**Broken Hill Mine Reclamation Project
Sanders County, Montana**

**DEQ Response to Public Comments on the Expanded Engineering Evaluation and
Cost Analysis (EEE/CA)**

Photo 1: Lower Adit Portal

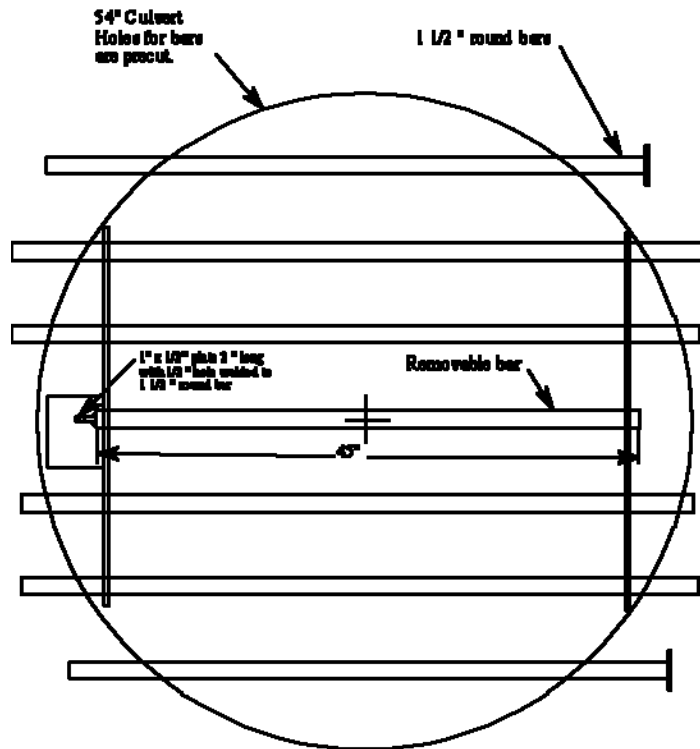
Comment 1, Mine Adit Openings: Our primary comments pertain to the adits that exist on the upper and lower excavation areas. Within the reclamation proposal document, MDEQ has the 2 existing adits scheduled to be closed during the restoration work. During the public meeting you indicated that the general plan was to place bat gates on the mine openings.

Answer 1: The lower adit portal is located on Forest Service property and is currently open (Attachment 1, Photo 1). The upper adit is located on private lands and appears to be completely collapsed. When a bat survey has not been performed at an abandoned mine project site, it is Department of Environmental Quality Abandoned Mine Section (DEQ AMS) general practice to place bat friendly closures on open mine features that may provide bat habitat. This is done to eliminate human and ecological safety hazards while maintaining bat habitat. A bat friendly closure consists of a culvert with a bat friendly grate placed either in the culvert or on the end of the culvert (Attachment 1, Photo 2).

Excavation and grading of the lower adit portal will be limited to removing the waste rock from the environment and providing access for the bat friendly closure placement. The waste rock will be hauled and placed in the repository. Since one of the purposes of DEQ AMS reclamation projects is to reduce safety hazards associated with open mine portals, the lower adit portal will not be excavated, opened, and graded for the purposes of allowing mine rehabilitation and human access. Future property owner access to the mine working would be through the culvert by removing the bar and lock. A key to the lock would be provided to the landowner.

Photo 2: Example Bat Friendly Adit Closure with Access

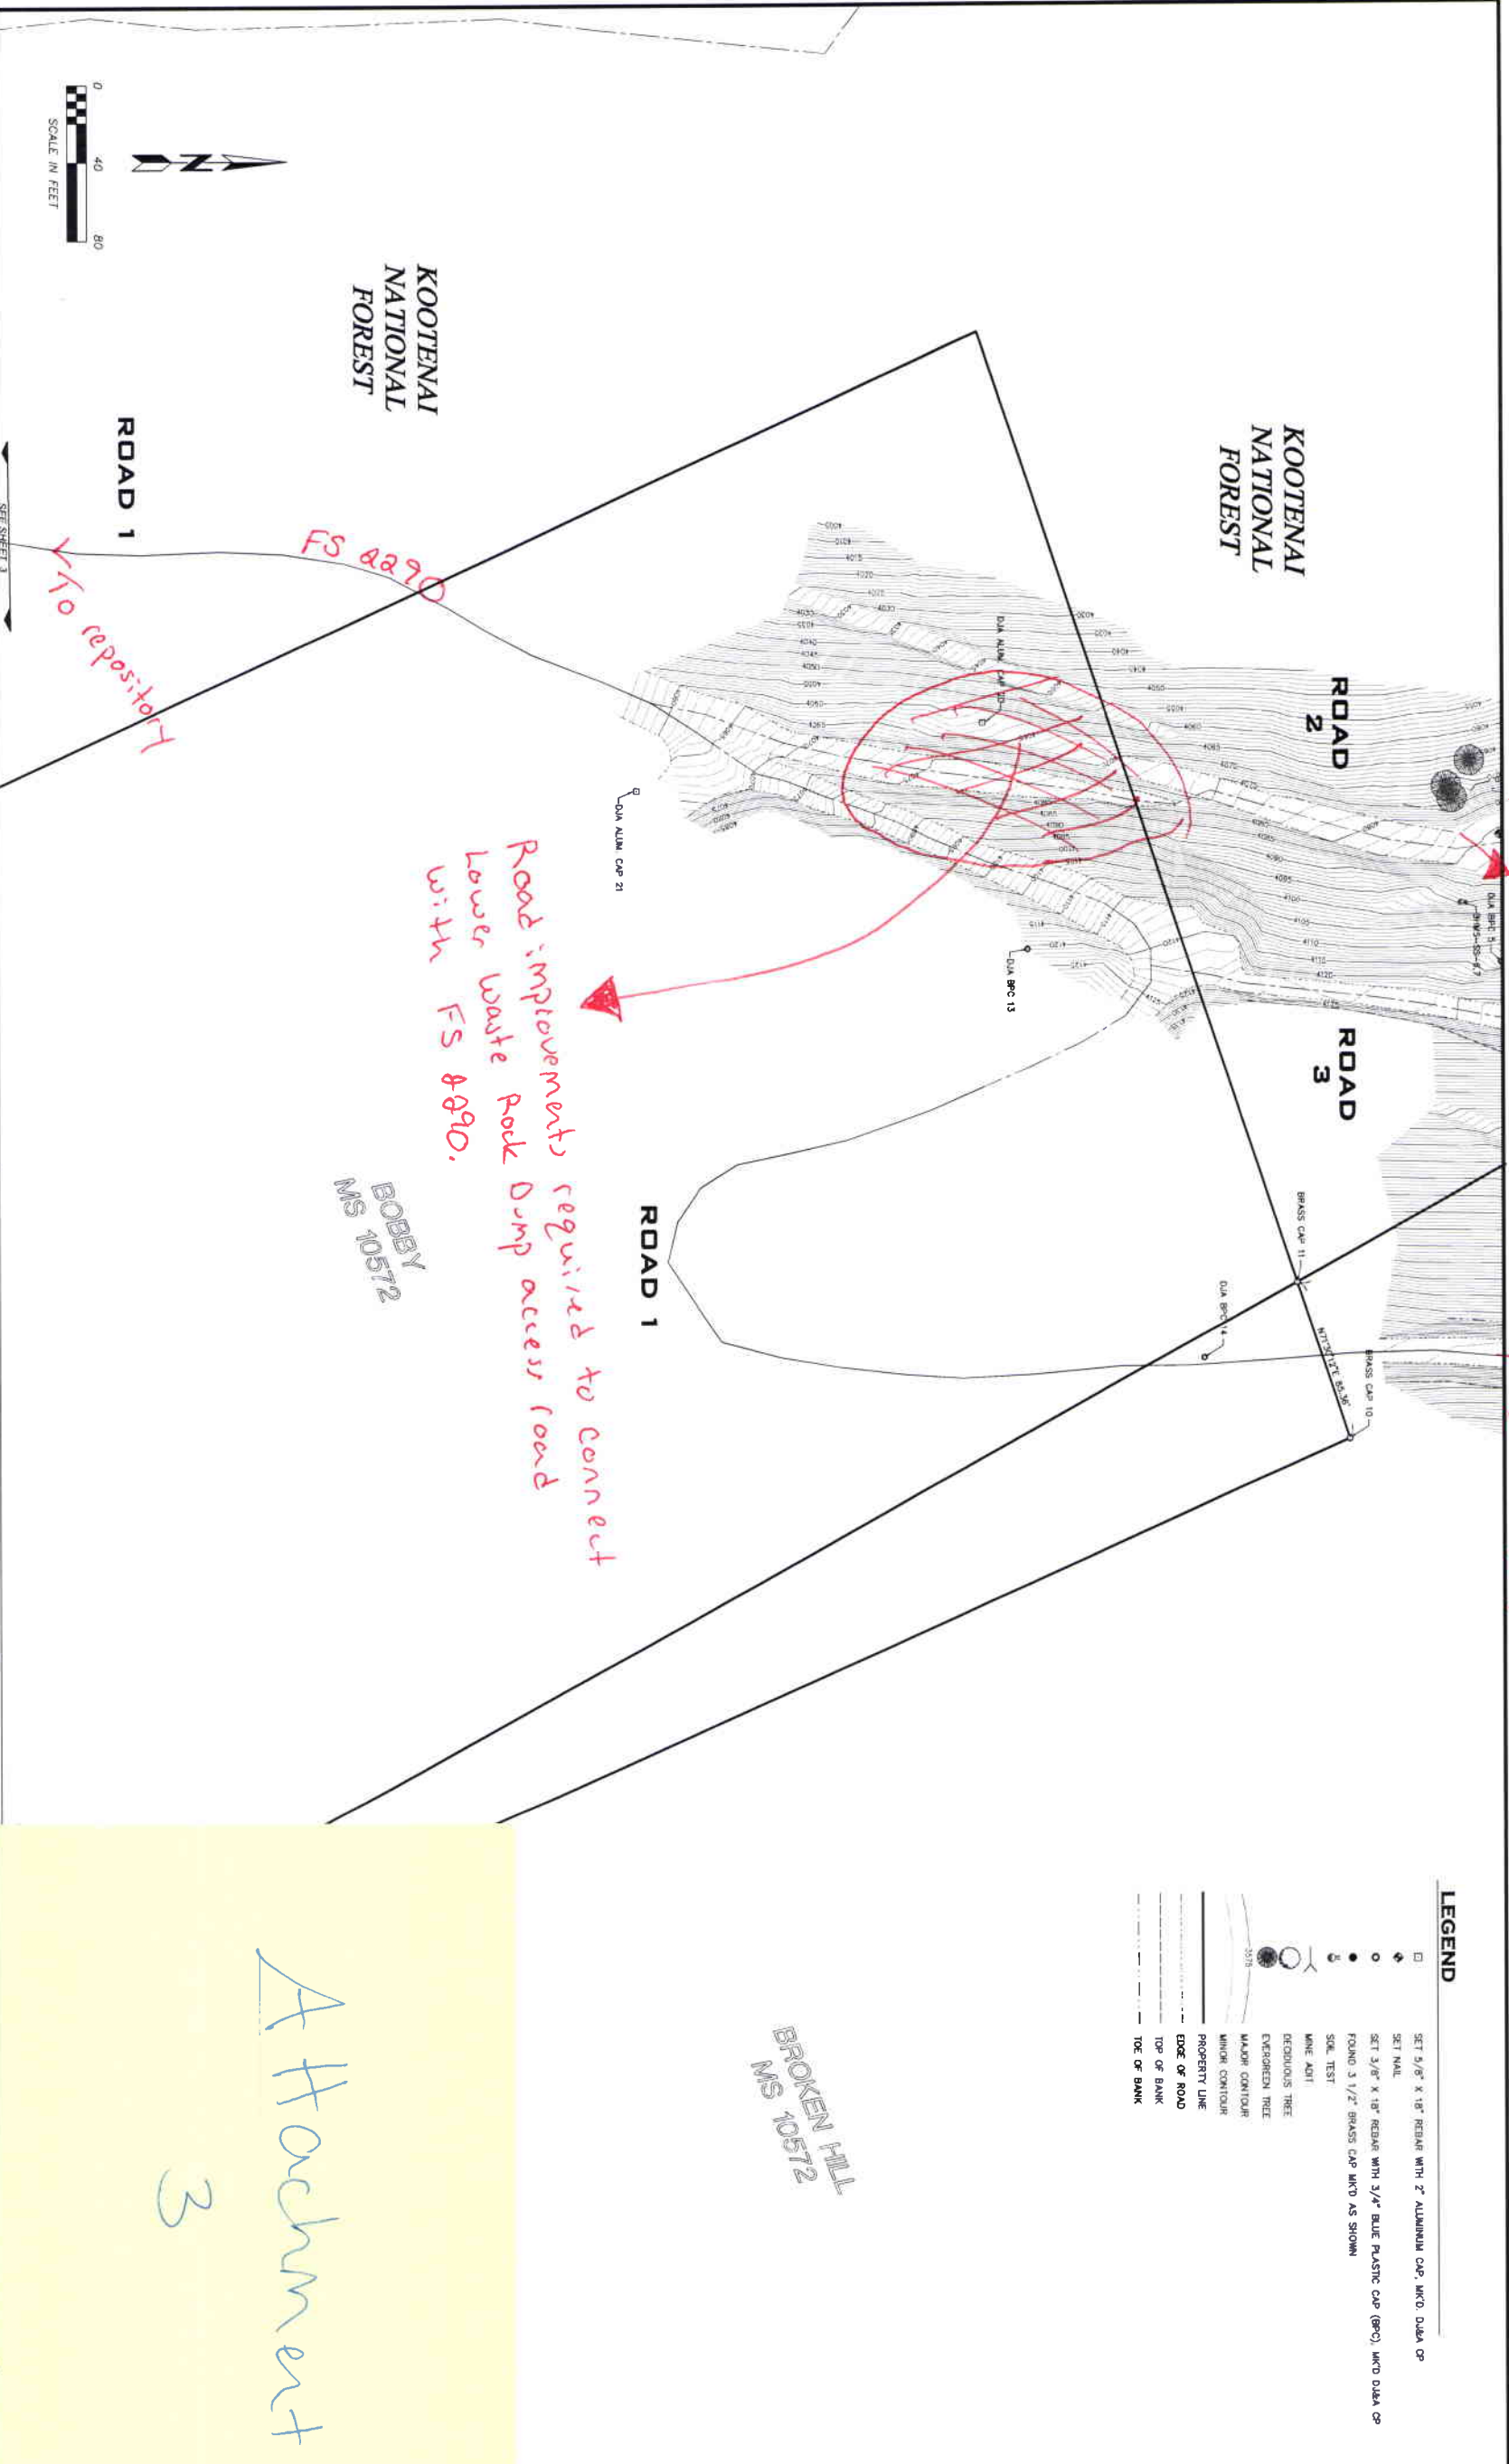
As landowners, we strongly support the proposed action of placing bat gates onto each of the adit openings. We would of course request a key to the gates for our personal access.

In the event the property owner wishes to have access to the mine working for future mining related purposes, a removable bar with a lock may be placed across the grate (Attachment 1, Photo 3). This culvert and grate is placed in the mine opening and the area around the culvert is backfilled and graded to match the surrounding topography. Attachment 2 shows a conceptual drawing of a typical bat friendly closure and access culvert. The actual design of the bat friendly closure will be completed during the Engineering Design and Bid Document Preparation phase of the project.
